Technical Permitting Workshop

Containment Plans

NTL 2010-N10 Containment: Common Submittal Errors

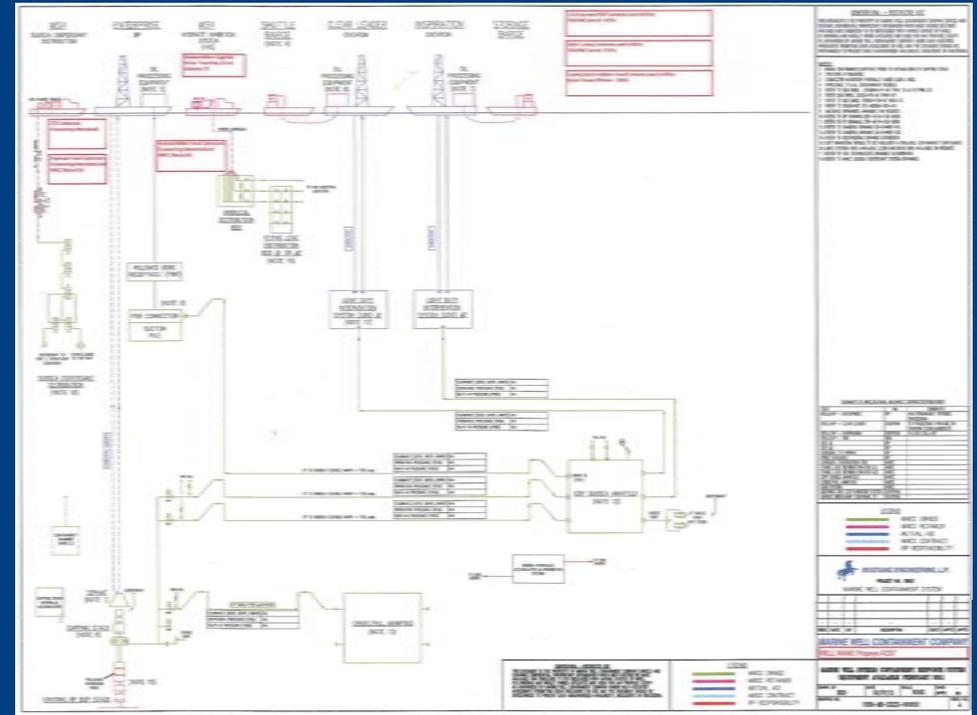
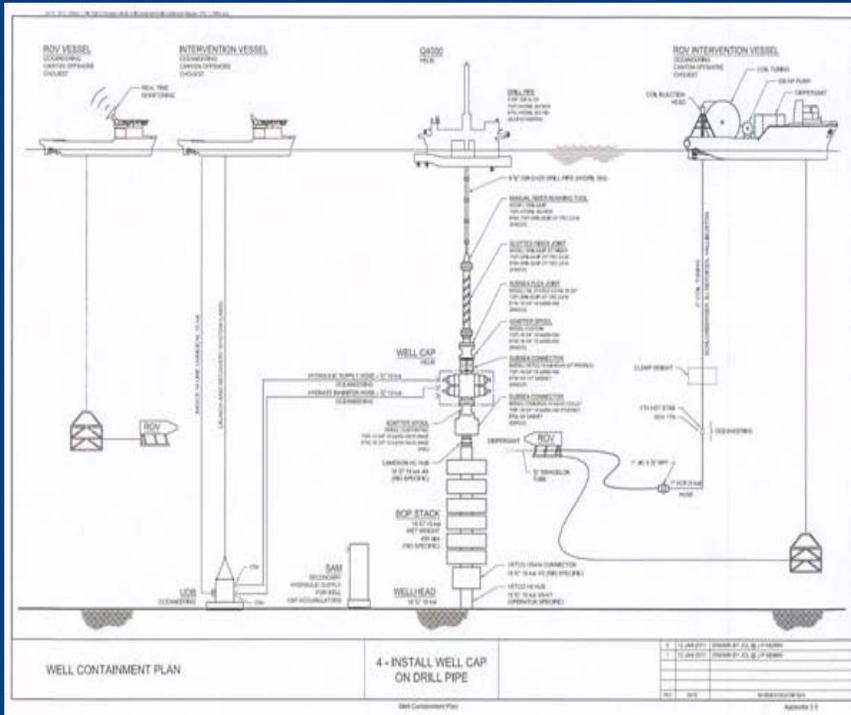
- Not providing a operator/well specific response PFD (Process Flow Diagram). Each plan should include a PFD that is specific to each operators' response capability. The generic version provided by MWCC and HWCG should be updated to be company specific.

SUBSEA CONNECTION

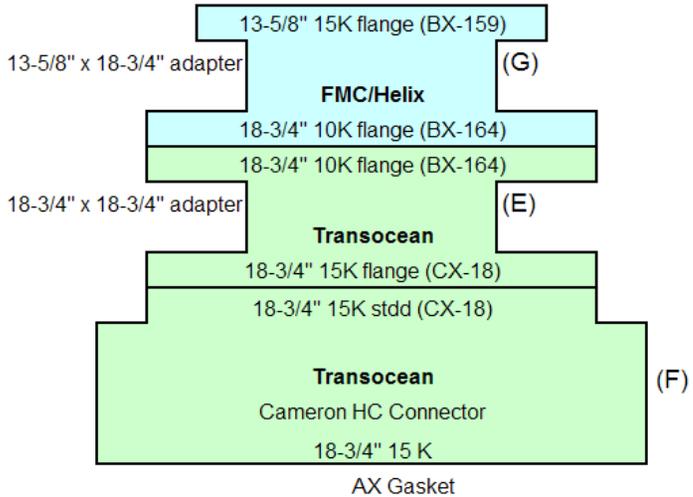
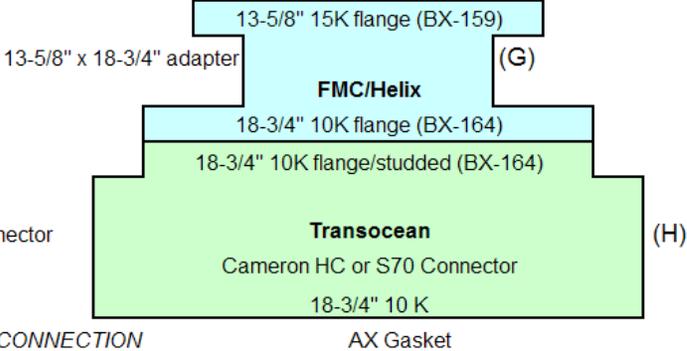
- Not specifying pressure ratings for all capping stack connectors. Internal to all plans is a “Capping Stack Connector/Transition Summary”. This document needs to specify the pressure ratings for all connectors.
- General failure to consider the possibility of a hydraulic connector release mechanism failure. We have seen an unwillingness to consider mechanical un-bolting of a flex joint connector.
